# CITY OF ALBUQUERQUE

**RE: Facility Build Storage  
5904 Florence Ave NE (Lot 18 Block 7 Tract A)  
Grading and Drainage Plan  
Engineer's Stamp Date: 6/6/2022  
Hydrology File: B18D030**

Based upon the information provided in your submittal received 6/6/22, the Grading & Drainage Plan **is not** approved for Building Permit or for Grading Permit. The following comments need to be addressed for approval of the above referenced project:

**DRAINAGE PLAN**

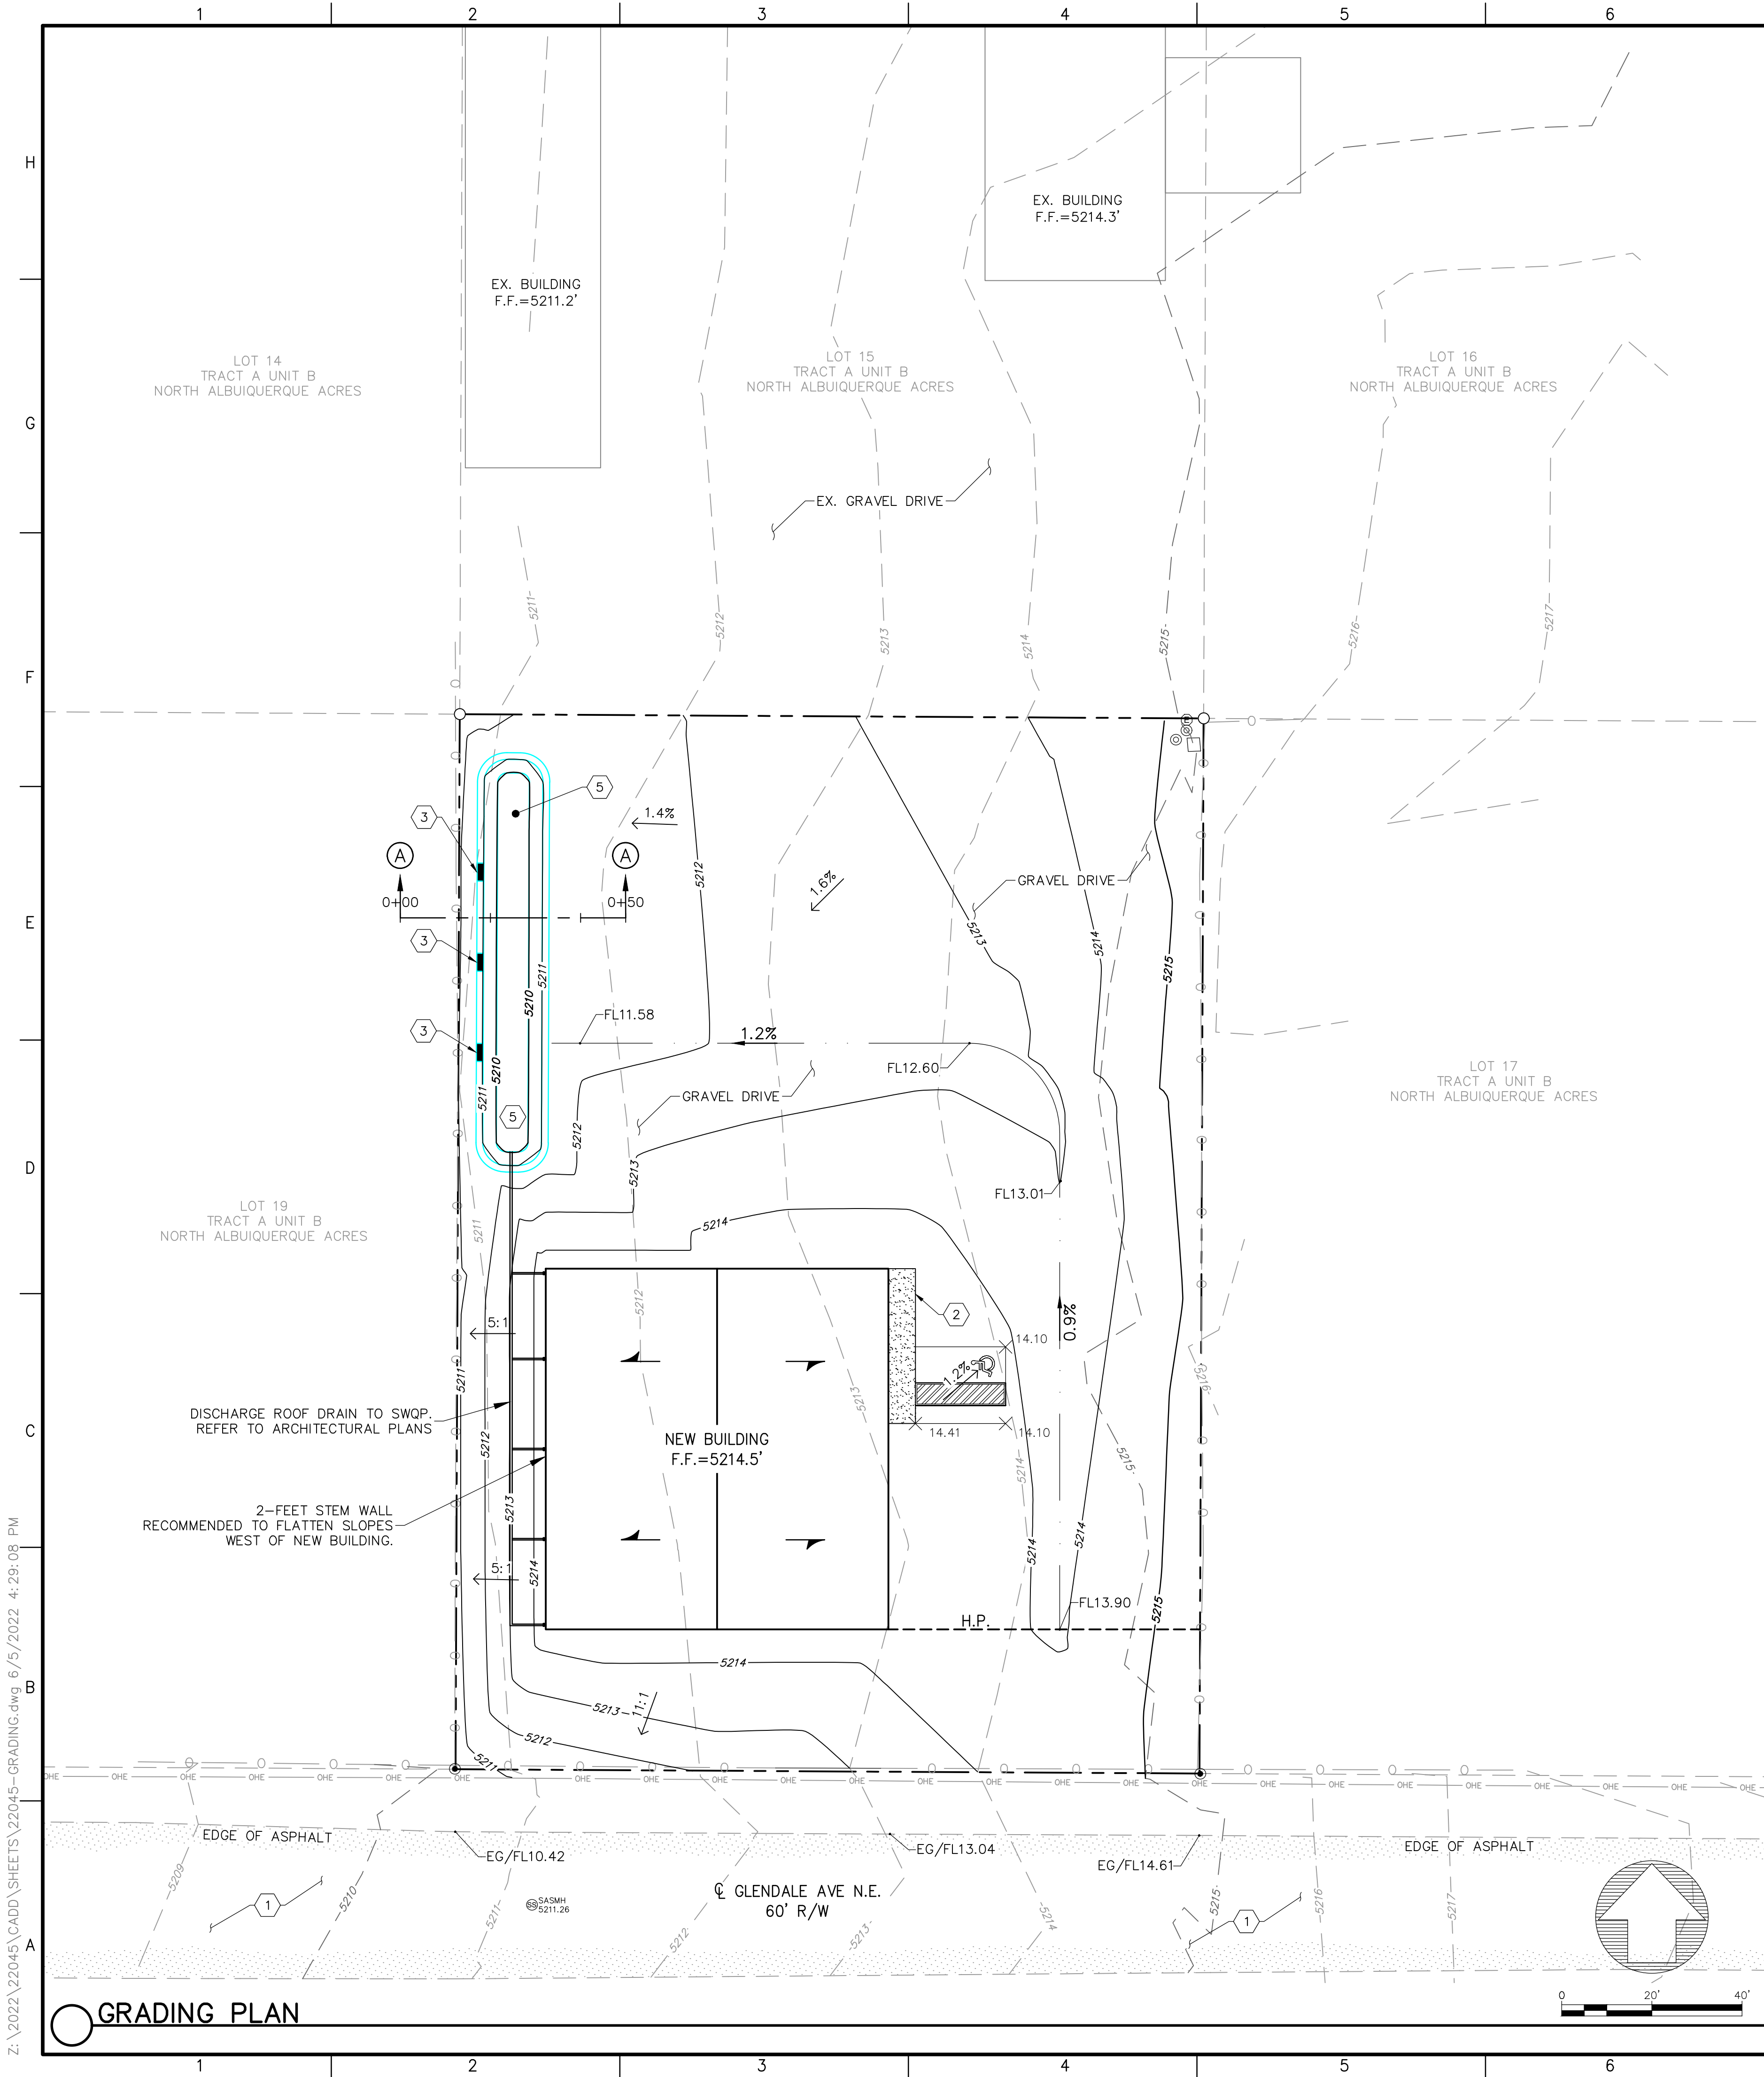
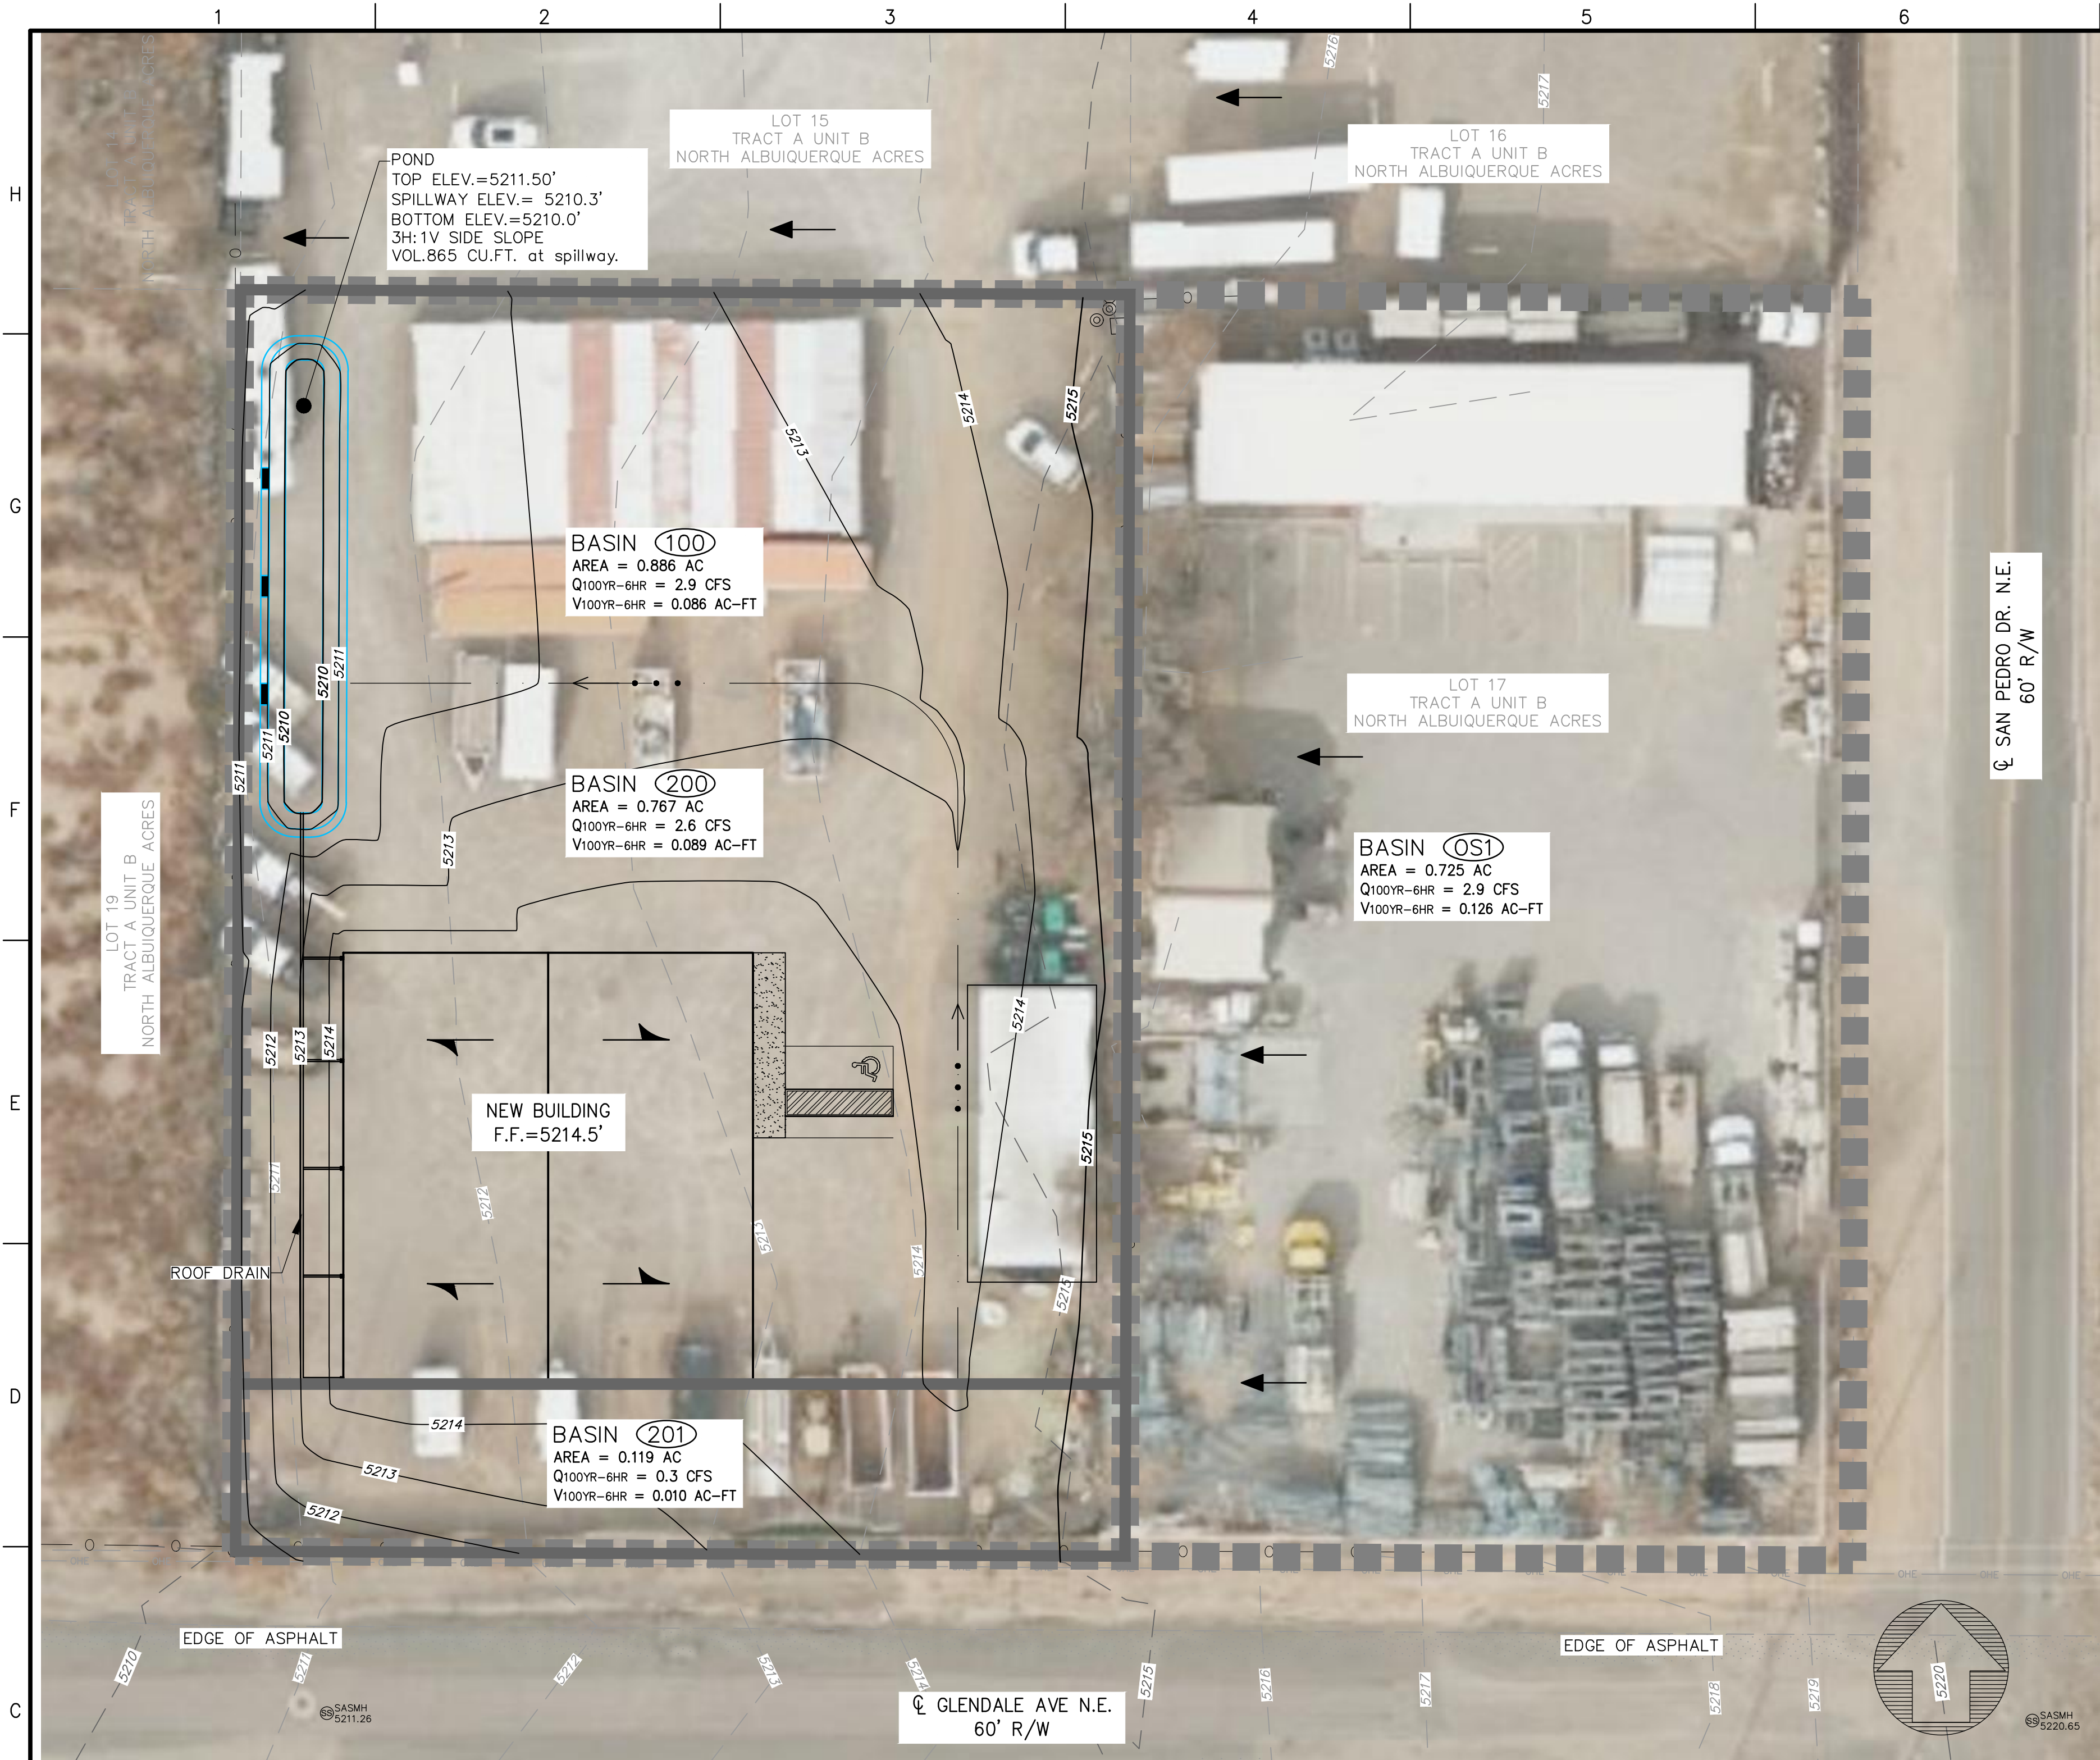
2. Clearly show where and how this will discharge into the street. The site cannot drain per historical drainage pattern and drain to adjacent site with the newly proposed development and must drain to the roadway when completed.

3. This may require an SO-19 depending on how flow will be directed to the roadway and what planning requires. If a work order is required for the roadway improvements drainage to the right-of-way whether a pipe or culvert can be included in that process as well.
